SERVICE INFORMATION LETTER NO. SIL20A1-009

EASA Emergency Airworthiness Directive No 2011-0067-E
ATA Code: 74 - Ignition

REPLACEMENT OF WASHER PART NO. 944072 (FLY WHEEL HUB) FOR ROTAX® ENGINE TYPE 912 AND 914 (SERIES)

SB-912-058

Fig. 1

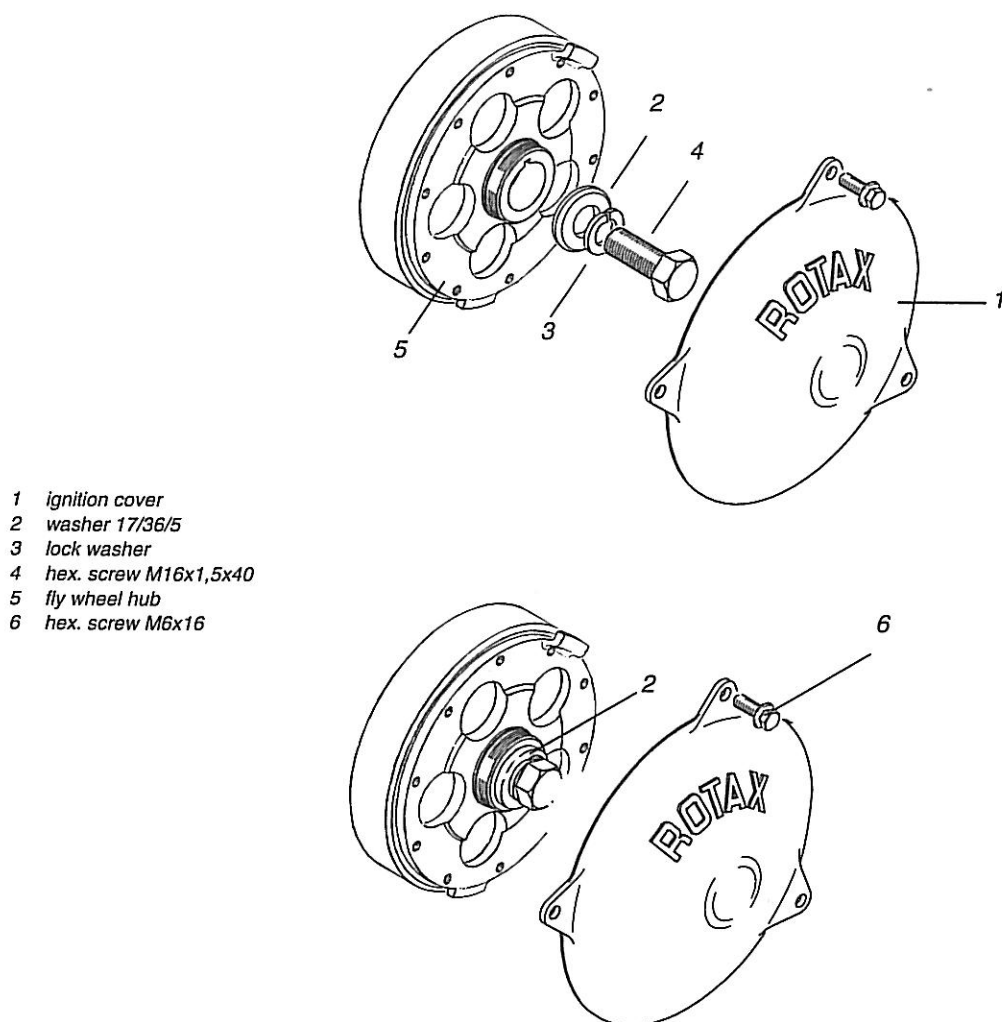
3.1) Replacement of washer part no. 944072

1. Remove ignition cover (1).
2. Lock the crankshaft in accordance with the relevant Maintenance Manual (Line).
3. Remove hex. screw (4) in accordance with the relevant Maintenance Manual (Heavy).

■ CAUTION: If the fly wheel hub has loosened during the disassembly and/or in case of doubt, then remove, clean and install the fly wheel hub in accordance with the relevant Maintenance Manual. In this case the tightening torque is 45 Nm (33.2 ft.lb) + 180° angle to rotation.

4. Install hex. screw (4). **Tightening torque 120 Nm (89 ft.lb).**

■ CAUTION: During installation the new washer (2) part no. 944072 must be used.

5. Remove locking pin of crankshaft in accordance with the relevant Maintenance Manual.
6. Check trigger coil gap, if necessary adjust it in accordance with the relevant Maintenance Manual.
7. Install ignition cover (1). The hex. screws (6) are locked with Loctite 221. Tightening torque 5 Nm (44 in. lb.).
